Project	IEEE 802.16 Broadband Wireless Access Working Group < <a href="http://ieee802.org/16">http://ieee802.org/16</a> >	
Title	QoS Control Scheme for data forwarding in 802.16j	
Date Submitted	2007-05-09	
Source(s)	<p>Hang Zhang, Peiyong Zhu, Mo-Han Fong, Wen Tong, David Steer, Gamini Senarath, Derek Yu, Mark Naden, G.Q. Wang</p> <p>Nortel 3500 Carling Avenue Ottawa, Ontario K2H 8E9</p> <p>Ranga Reddy US Army - CERDEC, USA</p> <p>D. J. Shyy MITRE, USA</p> <p>Arnaud Tonnerre</p> <p>THALES COMMUNICATIONS, FRANCE</p> <p>Djamal-Eddine Meddour</p> <p>FRANCE TELECOM, FRANCE</p> <p>Jeffrey Z. Tao, Koon Hoo Teo, Jinyun Zhang</p> <p>Mitsubishi Electric Research Lab 201 Broadway Cambridge, MA 02139 USA</p> <p>Toshiyuki Kuze</p> <p>Mitsubishi Electric Corp 5-1-1 Ofuna Kamakura, Kanagawa 2478501, Japan</p> <p>Aik Chindapol Jimmy Chui Hui Zeng Siemens Corporate Research Princeton, NJ, 08540, USA</p> <p>Teck Hu Siemens Networks Boca Raton, FL 33431, USA</p> <p>Yuan-Ying Hsu Telcordia Applied Research Center Taiwan Co., Taipei, Taiwan</p> <p>Tzu-Ming Lin, Fang-Ching Ren, Chie Ming Chou, I-Kang Fu ITRI/ NCTU Taiwan 195, Sec. 4, Chung Hsing Rd. Chutung, Hsinchu, Taiwan 310, R.O.C.</p> <p>Torsten

Figure 1. Relay MAC header format with proposed 3-bit “priority field”

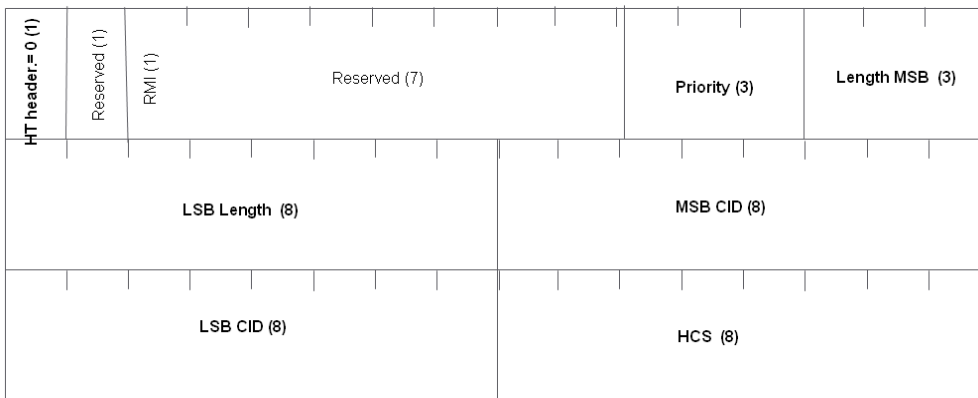
1. Use 3 bits in the “reserved field” of the relay MAC header defined in 07/198r8 as a “priority field” to indicate the priority of the associated MPDU.
2. This 3-bit “priority field” is used for RS to prioritize the data traffic along the relay path between BS and access RS
3. This approach is applicable to distributed scheduling relay system

Figure 1 below provides an example of where the 3-bit “priority field” could be in the relay MAC header specified in 07/198r8.

3-bit “priority field” is used in the relay MAC header to indicate the priority of the associated MPDU. The location of “priority field” in relay MAC header is to be determined.
